Palisades Nuclear Plant
Docket 50-255
License No. DPR-20

Response to NRC Requests for Additional Information Relating to License Renewal
dated October 24, 2005

**NMC Response to NRC Request for Additional Information (ML052980033)
Dated October 24, 2005**

**NMC Responses to NRC Requests for Additional Information (ML052980038)
Dated October 24, 2005**

...StationBlackoutSketch.DGN 11/14/2005 9:32:11 AM

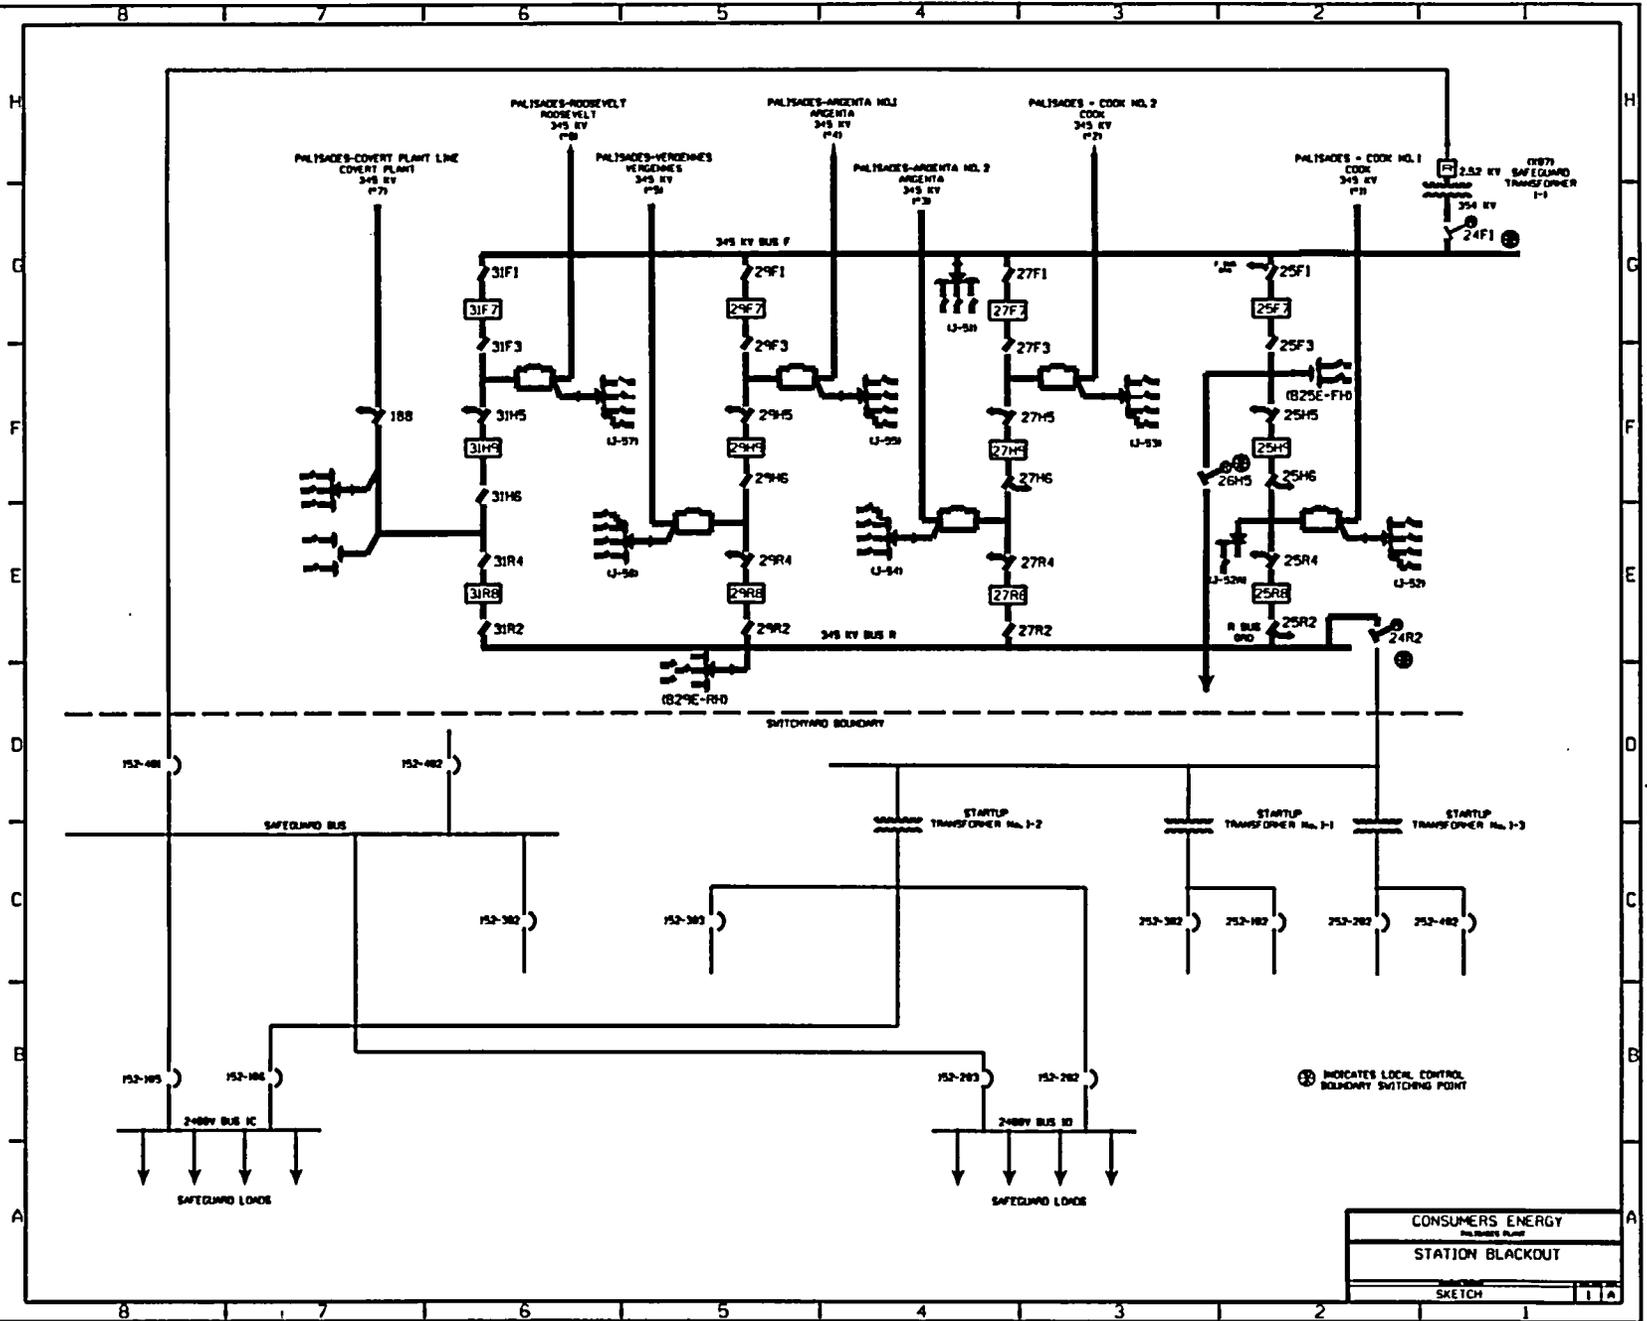
In Interim Staff Guidance-2 (ISG-2), the staff has determined that the plant system portion of the offsite power system that is used to connect the plant to the offsite power source should be included within the scope of the rule. This path typically includes the switchyard circuit breakers that connects to the offsite system power transformers (startup transformers), the transformer itself. In Section 2.5.9, you have provided license renewal boundaries of the switchyard. They included 345 kV Bus F, motor operated disconnect to the safeguard transformer and 345 kV Bus R and motor operated disconnect to the startup transformers.

- (a) Provide justification of not including the switchyard circuit breakers.
- (b) The 345 kV Bus F and R are not in scope for LR per Palisades Substation per drawing (LR-WD-1421-31). Clarify this discrepancy.
- (c) Revise the switchyard system function listing (SWY-01 to SWY-05) as appropriate.

As discussed in the NMC letter to the NRC dated August 27, 2005 (ML052440284), Palisades' scoping for Station Blackout meets the guidance of ISG-2.

The Palisades plant electrical distribution system connects to offsite power from the transmission system through several breakers that are individually operated to supply the desired plant bus(es). On the switchyard supply sides of these breakers is a transformer (Safeguard Transformer 1-1 or Startup Transformer 1-2) to step down the 345KV transmission system voltage to the 2400 VAC needed to supply the desired plant AC bus. The final connections between the primary sides of the transformers and the Palisades Switchyard F or R Buses are made via motor operated disconnects. The plant electrical distribution system is connected to or isolated from the transmission system with the breakers on the secondary (2400 VAC) side of the transformers. The motor operated disconnects on the primary sides are always closed unless they are deliberately opened (by local or remote manual operation) for maintenance; they are not operated to interrupt offsite power from, or restore offsite power to, plant systems. As shown on the Palisades drawings LR-WD-1421-31 and LR-WD-950 Sheet A, referenced in the LRA, these plant breakers are in scope for license renewal. In addition, the drawings also show that the upstream transformers and the motor operated disconnects have been included in scope. The transmission system and switchyard, including switchyard buses F and R which are used to interconnect the seven 345KV transmission lines that terminate in the switchyard, are not plant systems, and are not in scope of license renewal. The Palisades main generator output to the transmission system that connects between switchyard breakers 25F7 and 25H9, is also not in scope since backfeeding via that line is not credited for SBO recovery.

A simplified sketch of information extracted from LR-WD-1421-31 and LR-WD-950-A is included below to illustrate the boundary between the transmission system (including switchyard F and R buses) and the plant electrical systems. The transmission system is shown in black, and the two plant system connections from the transmission system in the switchyard to the plant electrical distribution buses, which are in scope of license renewal, are shown in red.
